BUILDING #1
CAROLINA FOREST
BUSINESS PARK
SURGEONS DRIVE, CAROLINA FOREST
MYRTLE BEACH, SC 29519

SHEET NO:
A-101

FLOOR PLAN
1/4"=1'-0"

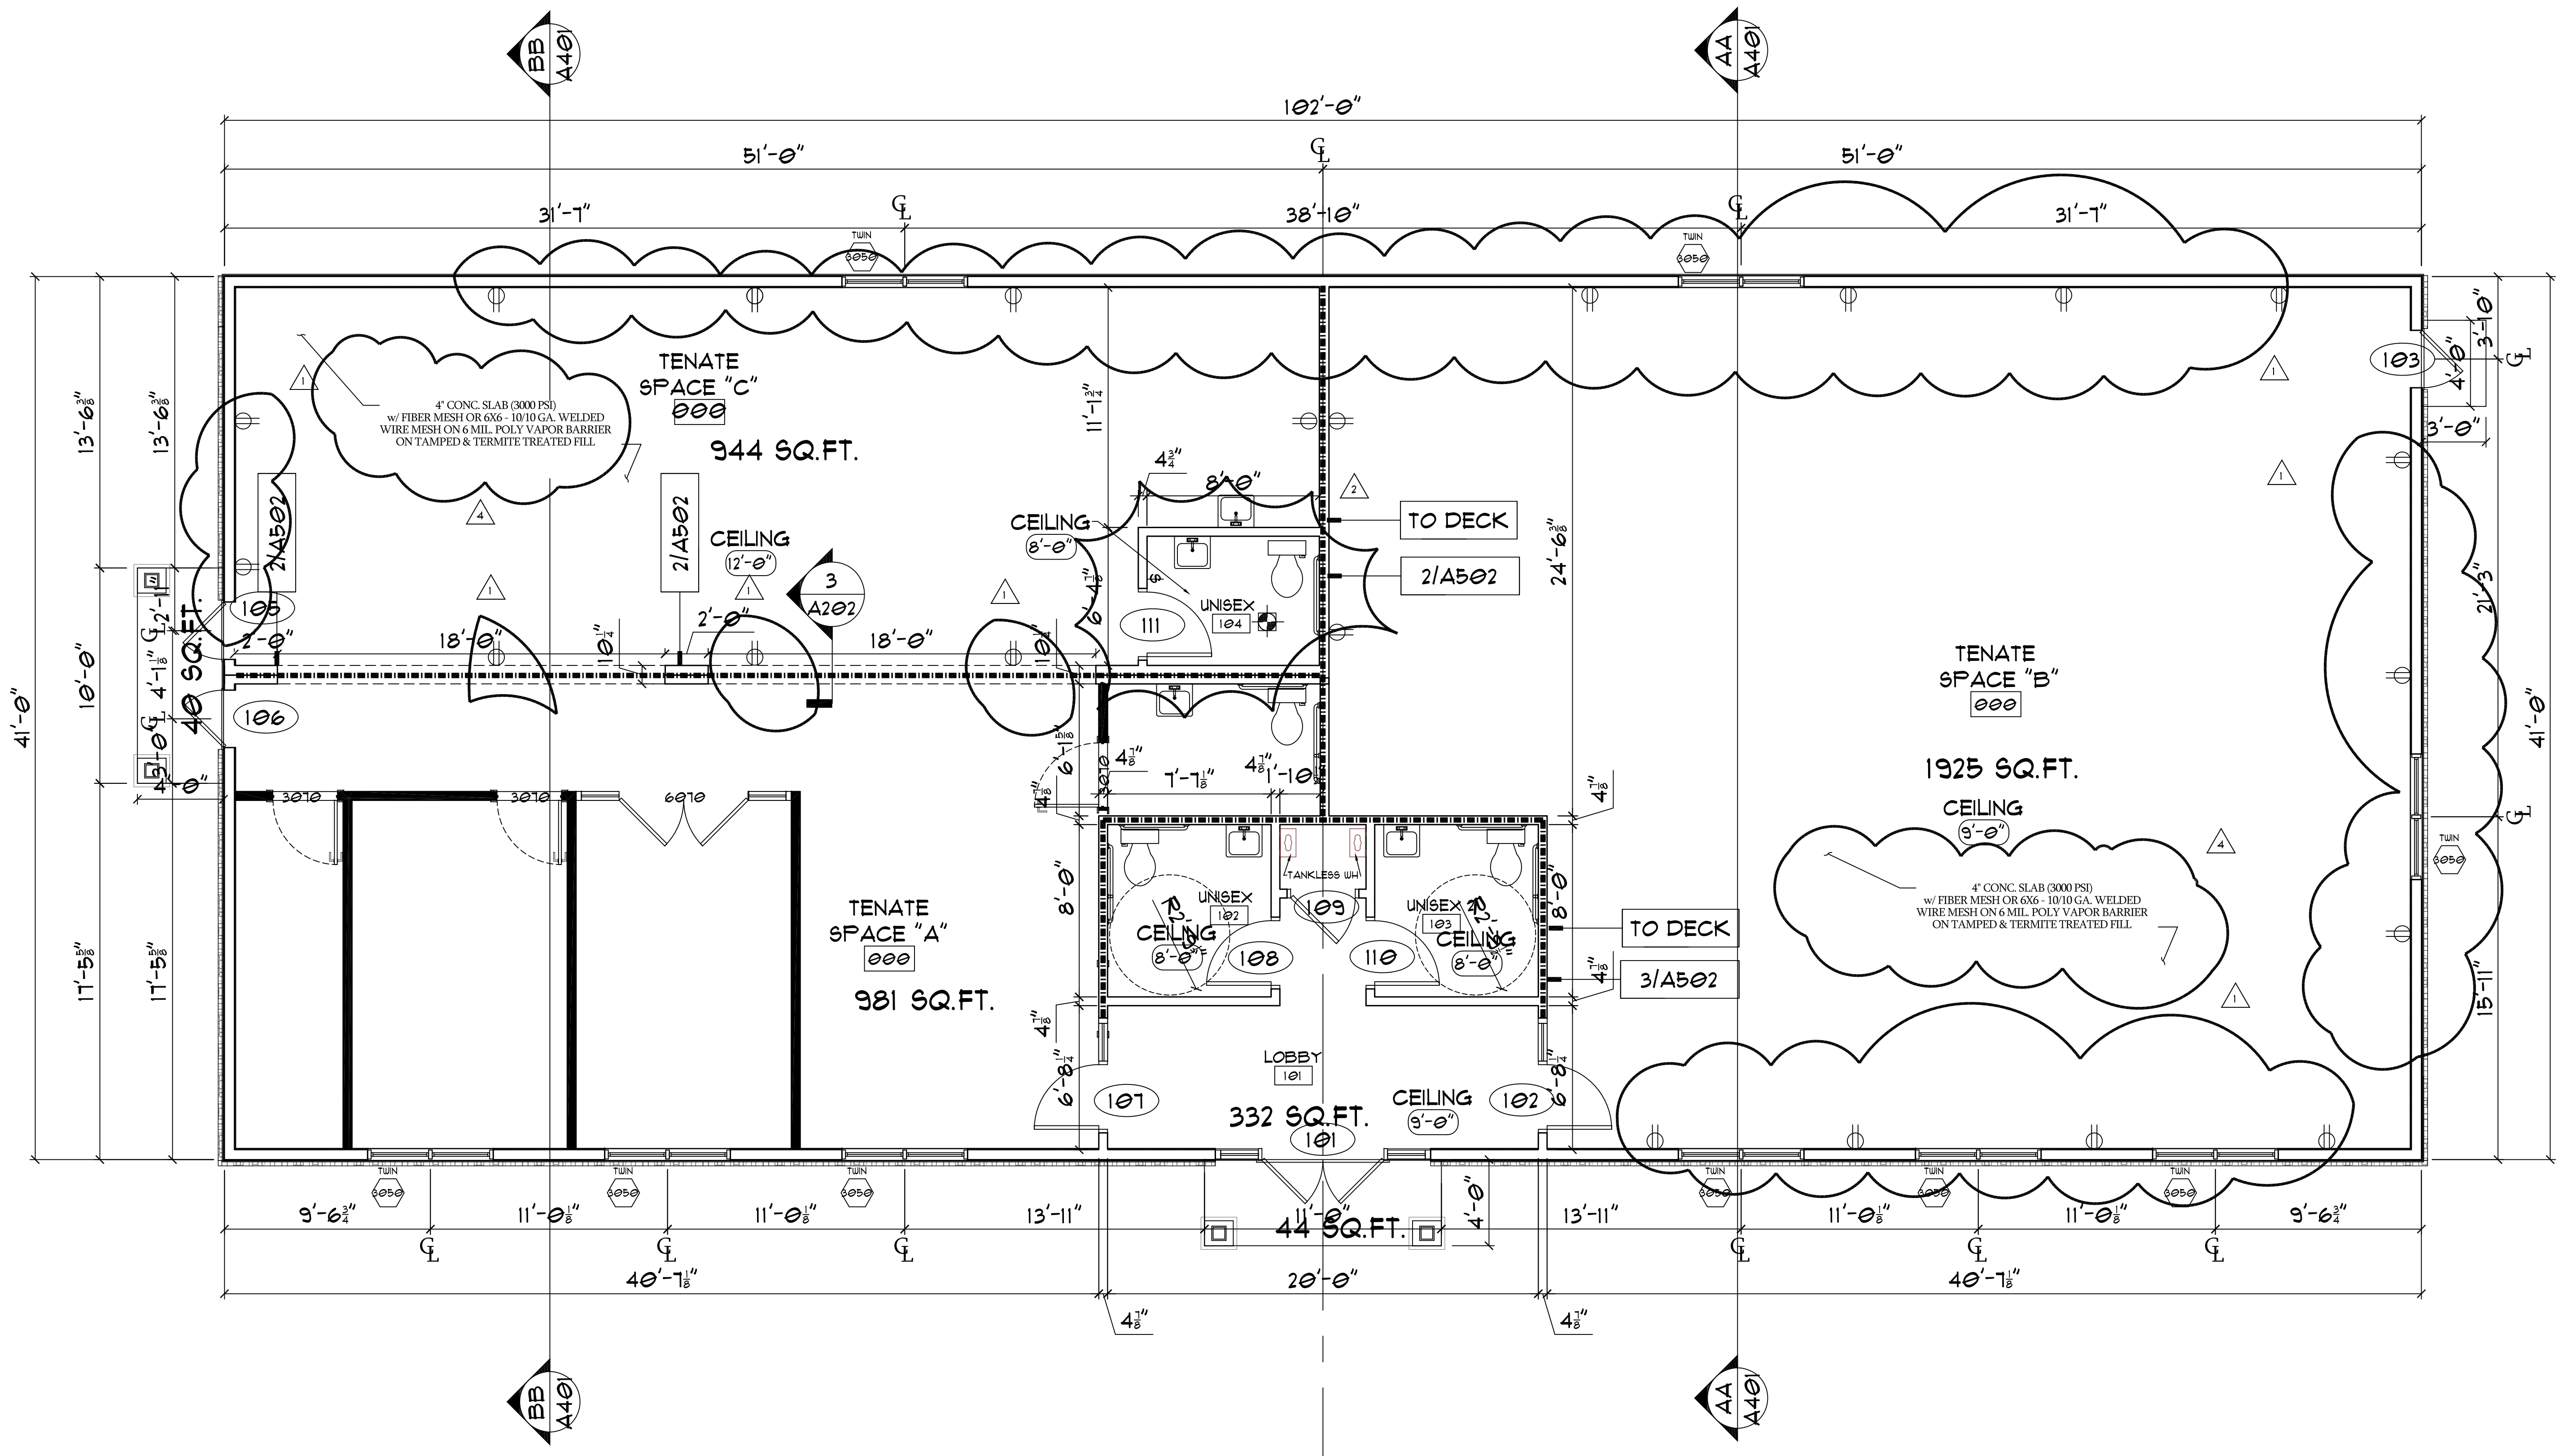
- 1. ADDED OUTLETS TO PERIMETER WALLS (PER CODE)
- 2. ADDED (2) SINGLE CLOSET RESTROOMS
- 3. ADDED DOORS III, TO DOOR SCHEDULE SH. A-501
- 4. ADDED FINISH FLOOR NOTE.
